NO. 16-095

SUBJECT: GRIFFITH PARK CRYSTAL SPRINGS – NEW BASEBALL FIELDS (W.O. #E170110B) PROJECT – PROPOSED PROJECT CHANGES; ADDENDUM TO PREVIOUSLY CERTIFIED ENVIRONMENTAL IMPACT REPORT

Addendum to the Environmental Impact Report (EIR) re Project Changes

Griffith Park Crystal Springs New Baseball Fields Project  
(W.O. #E170110B)

**REVISED PROJECT LAYOUT**

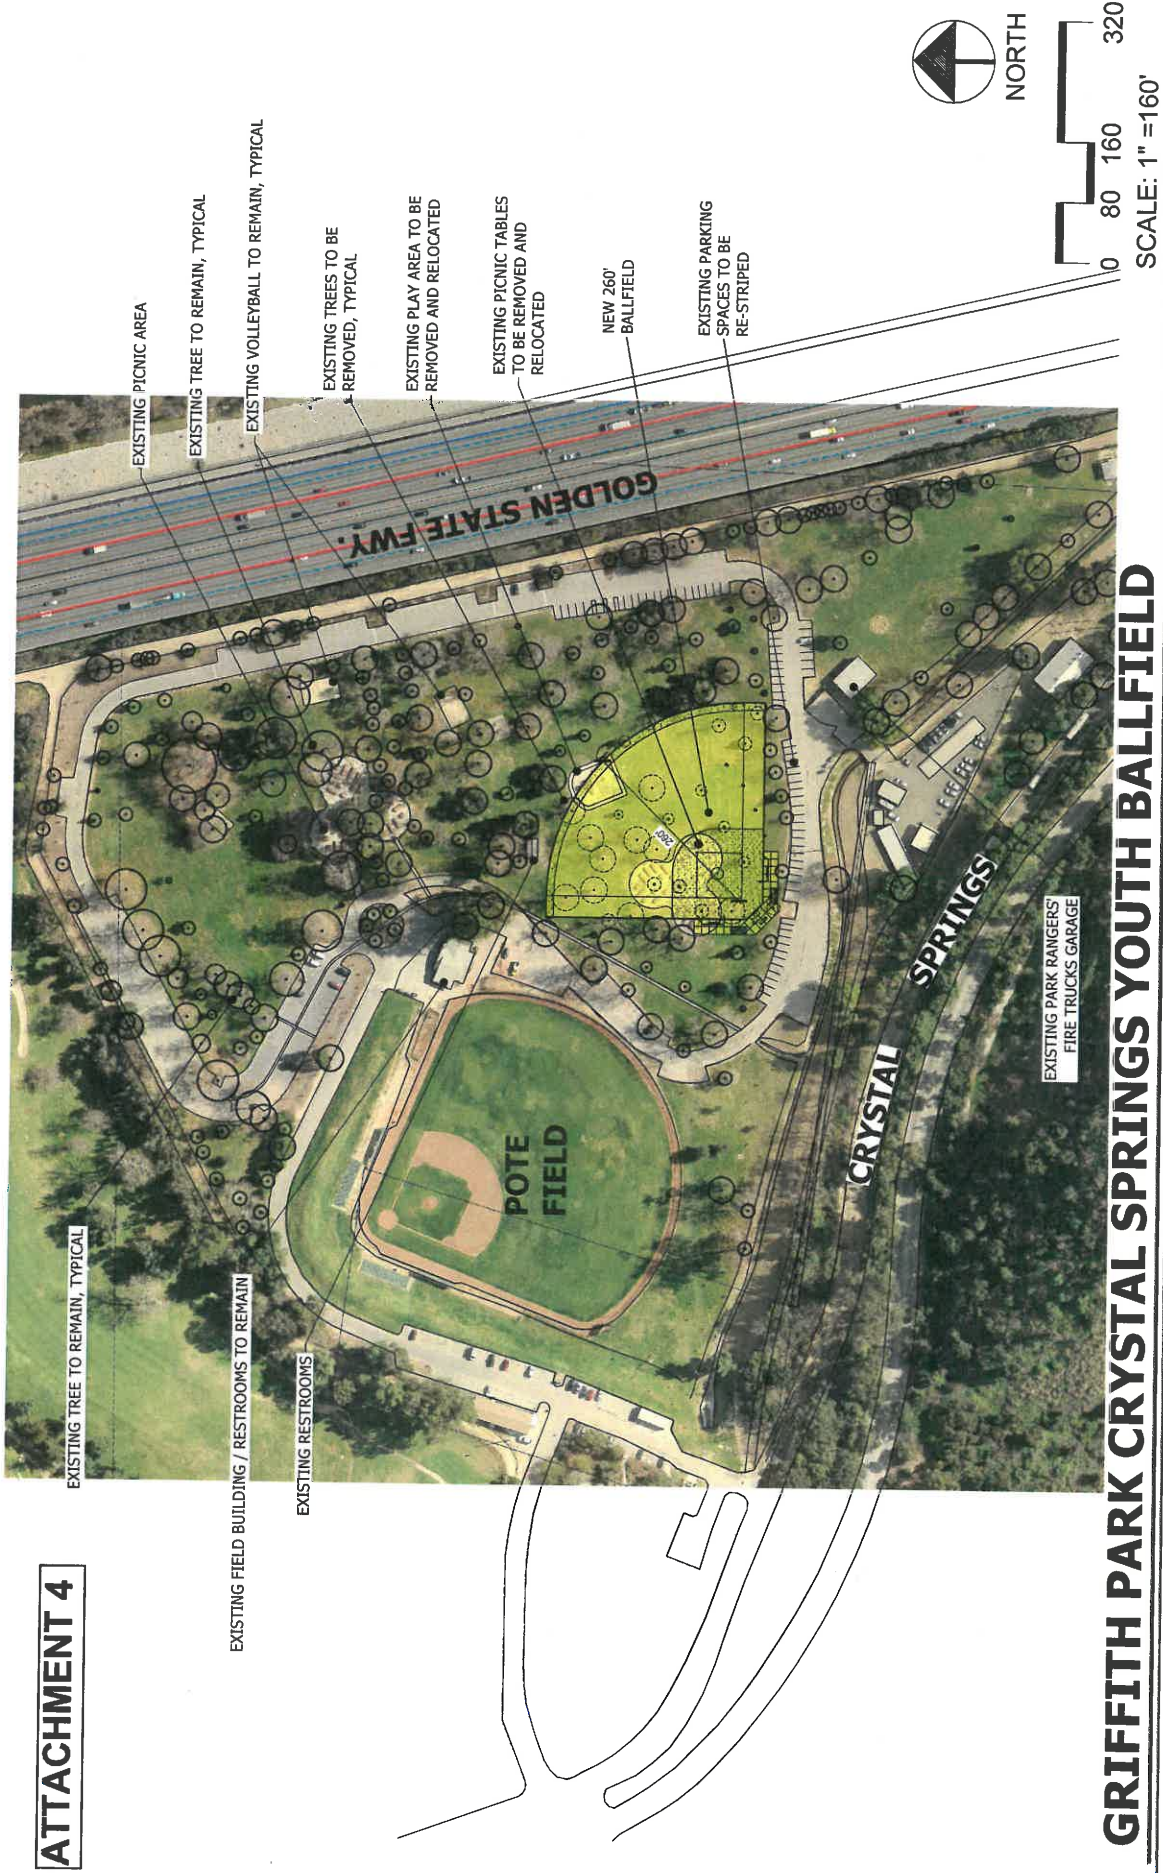
Under the contingent settlement, the Project would be changed to construct only one new youth baseball field at the Crystal Springs Picnic Area, instead of two fields. This field would be located, as depicted in Attachment 4 to this Report, in a portion of the previously described Project site for EIR Alternative 1B. The single field would be larger in size, measuring 260 feet from home plate to the centerfield fence, which would be up to 30 feet high. Changes to the existing access loop driveway and the related reduction in parking spaces in the original project would be eliminated. With the project changes, approximately fifty-six (56) picnic tables and a children's play area would be relocated. The number of trees required to be removed and replaced would be reduced to approximately thirty-two (32) generally small trees, and the heritage Sycamore tree would not be required to be removed.

Subsequent to the certification of the EIR, the Bureau of Engineering revised the design of the project (Revised Project). The Revised Project would construct one (1) new youth baseball field on approximately 2.1 acres within the southern portion of the existing Crystal Springs Picnic Area. The single field would measure 260 feet from home plate to the centerfield fence which would be up to 30 feet high. As with the Proposed Project, the field would have natural grass and a dirt playing surface, two (2) dugouts, bleachers, outfield and perimeter fencing, and scoreboards. The Revised Project also includes landscaping, an irrigation system, ADA path of travel, and security lighting. There would be no changes to the access loop driveway and no reduction in the number of parking spaces. Approximately fifty six (56) picnic tables and the children's play area would have to be relocated. The Revised Project would result in the removal and replacement of approximately 32 trees. The constructed baseball field would be operated and maintained by the Department of Recreation and Parks (RAP).
